Presentation to the City of Seattle

Design Review Board Recommendation Meeting

DPD #3011428

COLMAN TOWER

VIEW FROM NORTHWEST

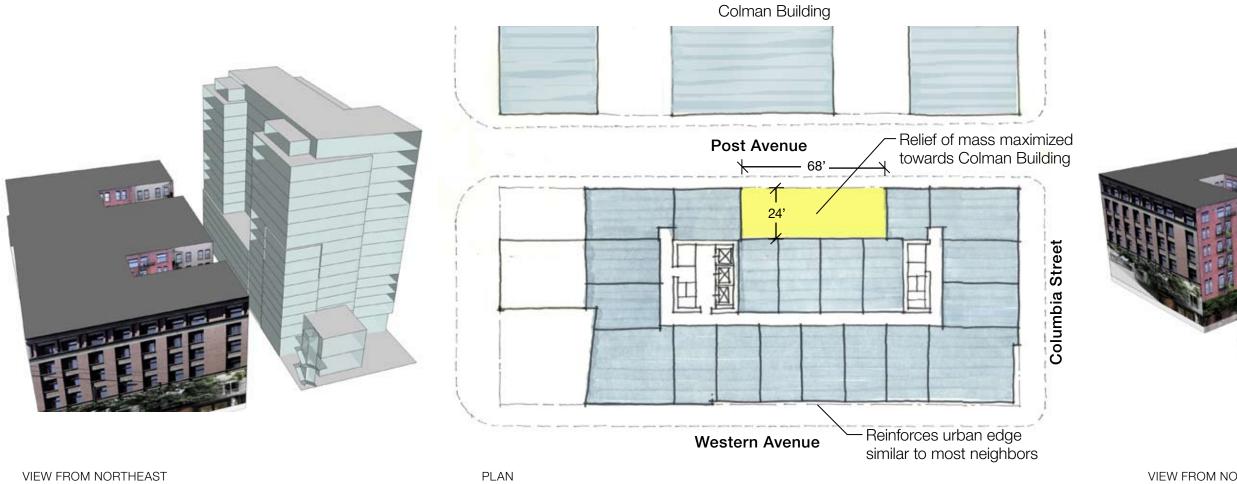
CODE SECTION	CODE REQUIREMENT	DEPARTURE REQUEST	DIFFERENCE	RATIONALE FOR REQUEST
Façade modulation SMC 23.49.058 B	Façade modulation is required above a height of eighty-five (85) feet above the sidewalk for any portion of a structure located within fifteen (15) feet of a street property line. No modulation is required for portions of a façade set back fifteen (15) feet or more from a street property line. Any portion of a façade exceeding 155' shall be set back a minimum of fifteen (15) feet from the street property line for a minimum distance of sixty (60) feet before any other portion may be within fifteen (15) feet of the street property line.	Eliminate the requirement to setback 15'-0", above 85', along the western façade in deference to maximizing relief to the Colman Building across Post.		The applicant proposes to focus all modulation and relief along Post Avenue where the right of way is extremely narrow (36'), providing a 24'-0" x 68'-0" setback along Post Avenue. The setback architecturally recalls the setbacks along the existing Colman Building along Post while the proposed frontage along Western Avenue is a more direct contextual massing response to the older buildings, which are typically "proud" to the property line, holding the street edge. This was generally supported by the DRB at the Early Design Guidance meeting.

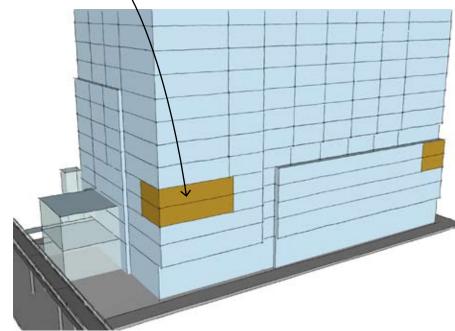
CODE SECTION	CODE REQUIREMENT	DEPARTURE REQUEST	DIFFERENCE	RATIONALE FOR REQUEST
Above grade parking treatment. SMC 23.49.019-B2.A.2	Parking above the third story of a structure shall be separated from the street by another use for a minimum of thirty (30) percent of each street frontage of the structure. For structures on lots located at street intersections, the separation by another use shall be provided at the corner portion(s) of the structure.	A departure has been requested to decrease the required active street frontage at levels 4 and 5 in exchange for providing more activation, but on four levels, not just two (floors 2-5).	Reduce requirement to: 0 % Along Post 0 % Along Columbia 30 % Along Western 21 % Along Marion	The design team proposes to provide active street facades in the form of studio "micro" apartments at the corner nearest Western and Marion. The configuration of the parking ramp (drive lane) precludes active uses along Post Avenue. To compensate for the departure, the design team proposes activating parking floors on all parking levels, 2-5, opposed to just the two required levels, 4 and 5, per the zoning requirement. This treatment provides a net gain of "activated area" on the building from the EDG. At the Early Design Guidance Meeting, the Board noted that on Western Avenue the residential units at the parking levels should be "shifted to the curtain wall area" so that the parking levels could be behind the punched masonry grid block area. This was generally supported by the DRB at the Early Design Guidance meeting. Note: The chart to the left is based on those percentages of activation facing Marion and Western to occur on all four levels of parking. Since DPD's standard requirement of 30% is for two levels, one can double the 21% and 30% numbers in the chart for a more direct comparison.

SECTION LOOKING EAST

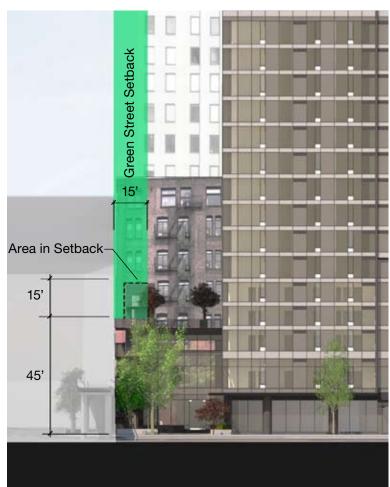
CODE SECTION	CODE REQUIREMENT	DEPARTURE REQUEST	DIFFERENCE	RATIONALE FOR REQUEST
Setback requirements on green streets SMC 23.49.058 F.2	When a lot in a DMC zone is located on a designated green street, a continuous upper-level setback of 15' shall be provided on the street frontage abutting the green street at a height of 45'.	Allow the public elevator shaft enclosure to encroach into the green street setback, from a height of 45' to 60'.	15' (for one, incidental elemant)	Since the EDG meeting, the applicant studied further the placement of the public elevator and stair to provide better, more convenient and "intuitive" use. This vertical circulation element connects Post Avenue, the existing pedestrian bridge, second floor retail, parking, the building's lobby and also accesses the public open space/"sunset terrace" at the roof of "the cube". Better proximity to the pedestrian bridge, than was presented at EDG, encourages and improves upon these connections. If the board supports the preferred option for the elevator/stair location (Option 3, page 28), this departure, if recommended, allows only the elevator (not the stairs, as they are below 45') to encroach into the green street setback, as a public amenity. Note: The applicant feels that in order to maximize this vertical circulator as a public amenity, it should go to the sunset terrace. If the elevator does not go to the roof terrace, this departure is not needed as the elevator structure serving only as high as the current pedestrian bridge would be less than 45' high. Note: The elevator enclosure is 5' south of the pedestrian bridge and the 91' tall Colman Building is right to its property lines, essentially masking the elevator from most views from the east, looking west.

POST AVENUE PLAN

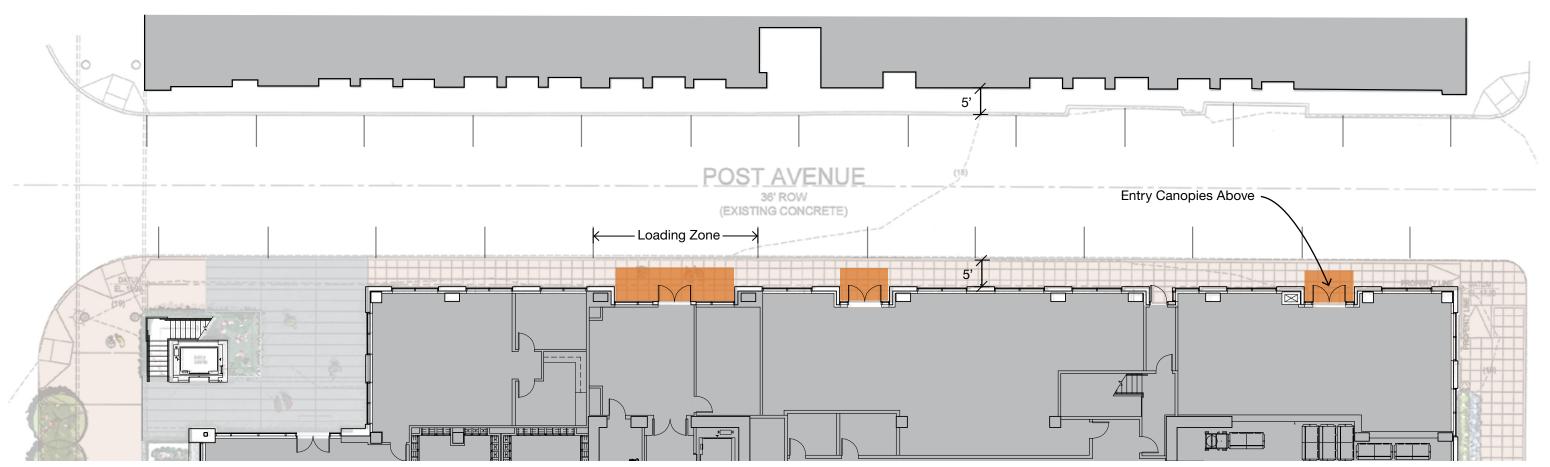
CODE SECTION	CODE REQUIREMENT	DEPARTURE REQUEST	DIFFERENCE	RATIONALE FOR REQUEST
Sidewalk width Downtown zoning map 1c	12' sidewalk is required on Post Avenue.	Allow the existing 5' wide sidewalk (albeit, replaced by a new concrete sidewalk)	7'-0"	Since this three-block section of Post Avenue does not show up in SDOT's sidewalk criteria map, 12' sidewalk width is a standard default dimension, typically applying to Right of Ways that are 66' or greater, throughout Seattle. Post's anomalous ROW is 36'. In order to provide a 12' sidewalk, the project would need to widen the sidewalk into the right of way (narrowing the street) or move the ground floor facade west, creating a 7'-0" overhang. The Seattle Dept. of Transportation does not support the sidewalk widening into the right of way. Moving the sidewalk under a deep overhang would hinder the viability of the commercial spaces along Post Avenue. Structural columns would likely need to also occur within such a 7' setabck.

The applicant has met with SDOT and SDOT supports a 5' sidewalk on the west side of Post, however, Streets and Bridges does not support any encroachment into the Row.

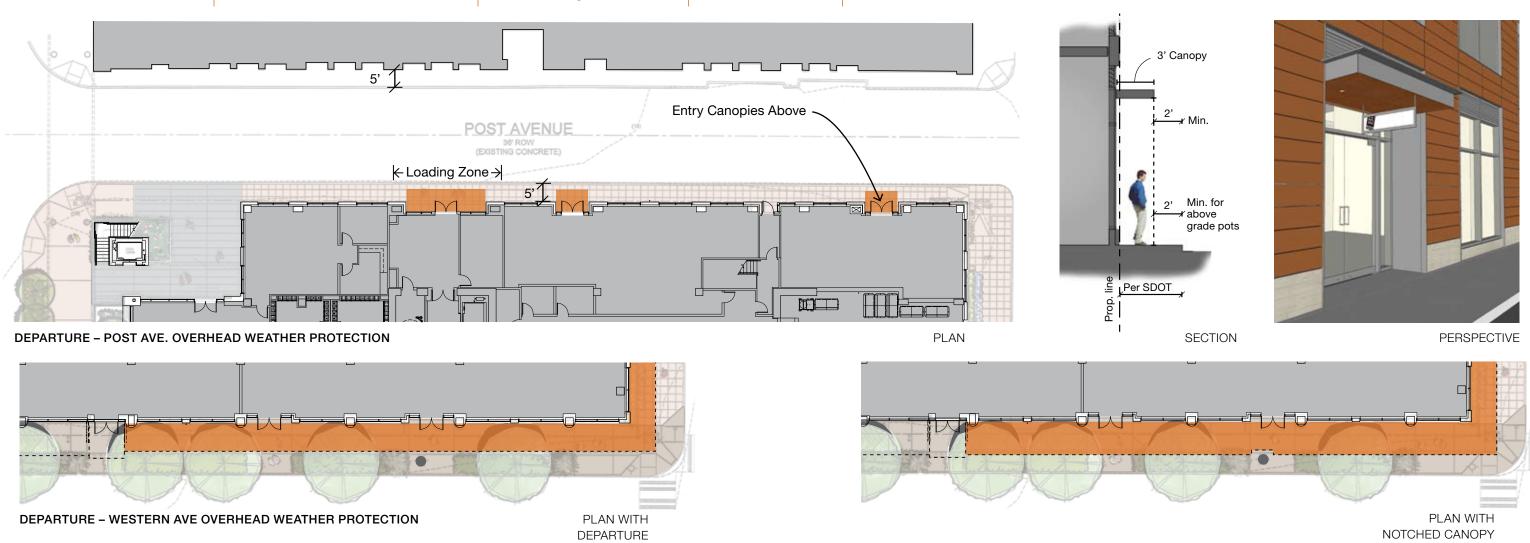
CODE SECTION	CODE REQUIREMENT	DEPARTURE REQUEST	DIFFERENCE	RATIONALE FOR REQUEST
Overhead weather protection-along post avenue SMC 23.49.018	Continuous overhead weather protection shall have a minimum dimension of 8' measured horizontally from the building wall or must extend to a line of 2' from the curb line.	A departure is requested to allow the omission of 186 linear feet of overhead weather protection. (156' along post and 30' along Columbia)	186 linear feet	Given a 5' sidewalk and the requirement to have the overhead weather protection be no less than 2' from the curb, a 3' deep canopy is the result. The small canopy would need to be a minimum of 10' above the sidewalk. With those proportions, weather protection is greatly reduced and mostly ineffective. The portion of the canopy in question is associated with the architectural element which wraps around the corner onto Columbia. For design consistency purposes the applicant proposes omitting 30' of canopy along Columbia St. The applicant proposes to provide deep canopies at the three entry locations on Post, for architectural interest and as visual organization and invitation/identification of entries.

Overhead weather protection-along Western Ave. SMC 23.49.018	Continuous overhead weather protection shall have a minimum dimension of 8' measured horizontally from the building wall or must extend to a line of 2' from the curb line.	A departure is requested to allow the reduction of the canopy depth from 8' to 7'-2" for 137 linear feet along the southern portion of the building.	10" less canopy depth for 137 linear feet	The proposed deduction is due to a conflict with the canopy and an existing street lamp. One alternative would be to keep the bulk of the canopies at 8' in depth, and "push in" the one canopy that is in conflict with the light pole.

BLANK FACADE ALONG COLUMBIA

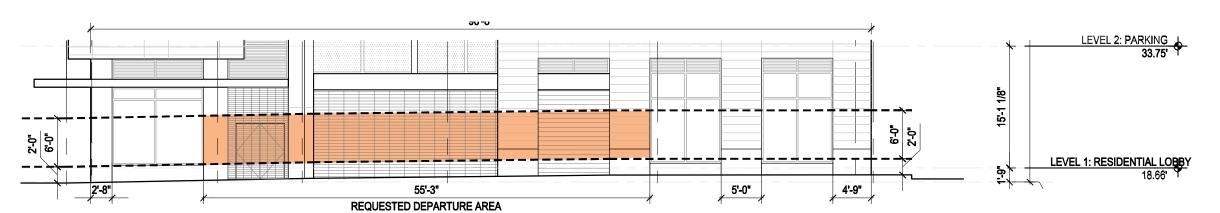
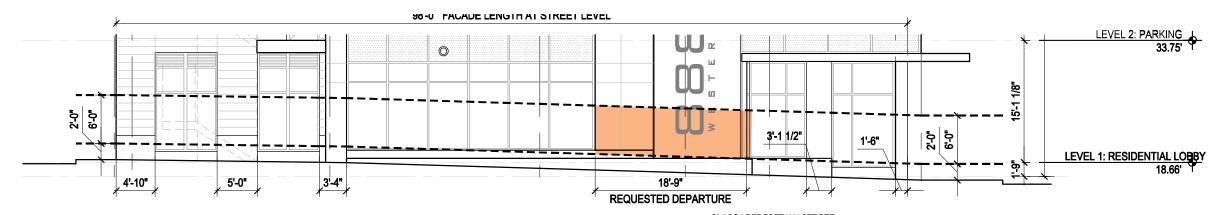
CODE SECTION	CODE REQUIREMENT	DEPARTURE REQUEST	DIFFERENCE	RATIONALE FOR REQUEST
SMC 23.49.056D Blank Façade	Columbia St.: Maximum blank façade length along class II pedestrian street is 30'	A departure is requested to allow a blank façade of 55'-3".	25'-3" more blank façade.	The proposed design intent is to create as much commercial use as possible along Post Ave., Marion st. and Western Ave. Due to the lack of an alley on this site, and following the design review board's direction, the building services have been co-located along Columbia St. In order to free up the areas on the other streets, creating more viable commercial areas.
SMC 23.49.056D Blank Façade	Marion St.: Maximum blank façade length along class I pedestrian street is 15'	A departure is requested to allow a blank façade of 18'-9"	3'-9" more blank façade.	The proposed design intent is to provide an architectural feature that accents the residential entry and helps diguise the parking levels. The blank façade is tucked into a corner with significant areas of landscaping in front of it. Although the façade is blank, it is architecturally dynamic and does not detract from retail frontage possibilities

MAX BLANK FACADE LENGTH ALONG CLASS II PEDESTRIAN STREET IS 30' MAXIMUM LENGTH PROVIDED 55' - 3" > 30' MAX BLANK FACADE PERCENTAGE ALONG CLASS II PEDESTRIAN STREET IS 70% 70% OF 96' - 8" = 67' - 8" = 67' - 8" PROVIDED

MAX BLANK FACADE LENGTH ALONG CLASS I PEDESTRIAN STREET IS 15' MAXIMUM LENGTH PROVIDED 18' - 9" > 15' MAX BLANK FACADE PERCENTAGE ALONG CLASS II PEDESTRIAN STREET IS 409 40% OF 98' = 39' - 1" > 36' - 7" PROVIDED

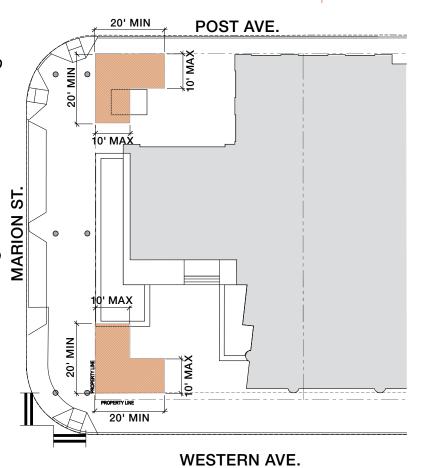
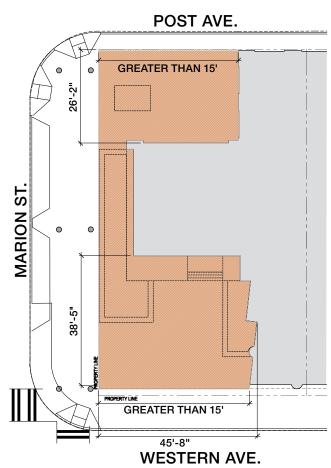
CODE SECTION	CODE REQUIREMENT	DEPARTURE REQUEST	DIFFERENCE	RATIONALE FOR REQUEST
23.49.0562B Façade setback requirements	The maximum area of all setbacks between the lot line and facade along each street frontage of a lot shall not exceed the area derived by multiplying the averaging factor by the width of the street frontage of the structure along that street (see exhibit d 23.49.056. The averaging factor shall be five (5) on class i pedestrian streets and ten (10) on class ii pedestrian streets and designated green streets.	Increase the Marion Street limit from 500 sf of setback to 3100 sf.	An increase of 2600 sf.	Thr proposed design seeks to improve Marion as a designated green street. Due to the WSDOT elevated ferry pedestrian bridge, the marion street sidewalk is largely covered. Creating 2 plazas flanking the residential entry allows the green street to flow out from under the bridge. We are incorporating significant areas of planting and hardscape plaza space for public use.

23.49.0562C Façade setback requirements	The maximum width, measured along the street property line, of any setback area exceeding a depth of fifteen (15) feet from the street property line shall not exceed eighty (80) feet, or thirty (30) percent of the lot frontage on that street, whichever is less.	Increase the Marion Street limit from 30' to 65'-0"	An increase of 35'	In order to create the plazas for public use, the amount of setback for areas 15+ feet in depth has been increased.

23.49.0562D Façade setback requirements	The maximum setback of the façade from the street property lines at intersections shall be ten (10) feet. The minimum distance the facade must conform to this limit shall be twenty (20) feet along each street.	Increase the maximum setback at the corner of Marion / Western and Marion / Post to to 45'-8"	An increase of 35'-8"	In order to create the plazas for public use, the maximum setback at the corners of marion and post and western have been increased.

SETBACK DEPTH: DEPARTURE REQUESTED MAX SETBACK DEPTH = 10'-0" SETBACK DEPTH = 40'-6 3/4" ALONG MARION 26'-11 3/8" ALONG POST SETBACK LENGTH: MIN SETBACK LENGTH = 20'-0" SETBACK LENGTH = 26'-2 3/8" ALONG MARION 40'-3 3/4" ALONG POST

SETBACK DEPTH: DEPARTURE REQUESTED MAX SETBACK DEPTH = 10'-0" SETBACK DEPTH = 43'-7 3/8" ALONG MARION 38'-5 1/8" ALONG WESTERN
